Technical Service Bulletin

72 Rear center seat rattles and does not fold flat

72 13 11 2023324/3 October 21, 2013. Supersedes Technical Service Bulletin Group 72 number 13-08 dated September 10, 2013 for reasons listed below.

Model(s)	Year	VIN Range	Vehicle-Specific Equipment
Q5	2009 - 2010	All	Not Applicable

Figure 2. Arrow indicates direction to insert screwdriver. The latch is shown in the locked position.

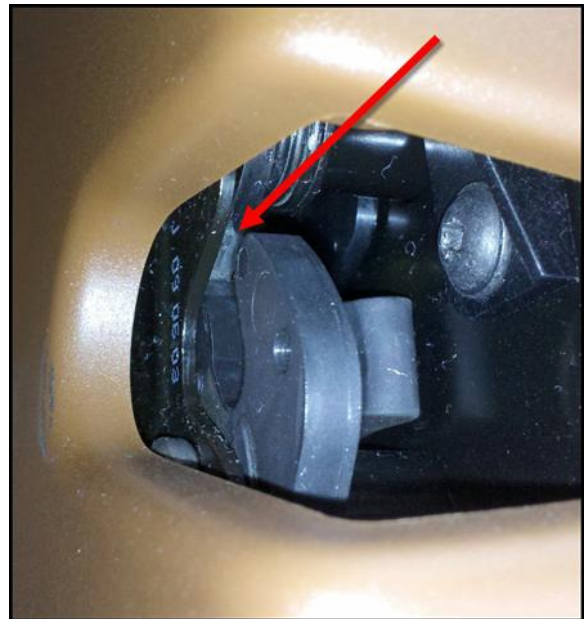
1. Manually unlatch the center backrest from the driver's side rear backrest. To do this, insert a small, flat, regular screwdriver (with an end width of 6 mm-8 mm) into the latch to release the locking mechanism (Figure 2).

The latch concept is the same as a door latch; pressing inward will release the latch.

Figure 3. The release lever button and lock cover (arrows).

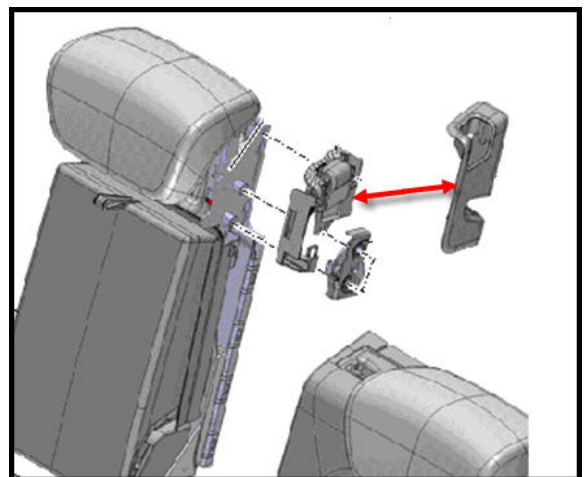
The connection between the release rod and the release lever is optimized. The release lever is optimized.

2. Use the repair instructions in Elsa to remove and replace the release lever button and the lock cover (Figure 3 and Figure 4).

Follow the instructions below to replace both the release lever and the lock cover.
